## APPENDIX 115E

# UNITIZATION PROCEDURES FOR BOXED AMMUNITION AND COMPONENTS ON 4-WAY ENTRY PALLETS

CARTRIDGE, IMPULSE, XM796, PACKED 2,160 PER WOODEN BOX, UNITIZED 12 BOXES PER 40" X 48" PALLET; APPROX BOX SIZE 23" L X 20" W X 11½" H

#### **REVISION**

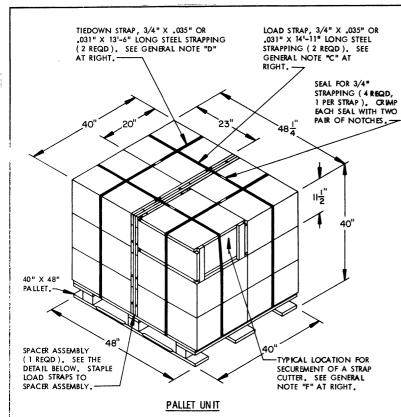
REVISION NO. 1, DATED MAY 1984, CONSISTS OF:

ASSIGNING NATIONAL STOCK NUMBER TO ITEM LISTED IN "PALLET UNIT DATA" CHART.
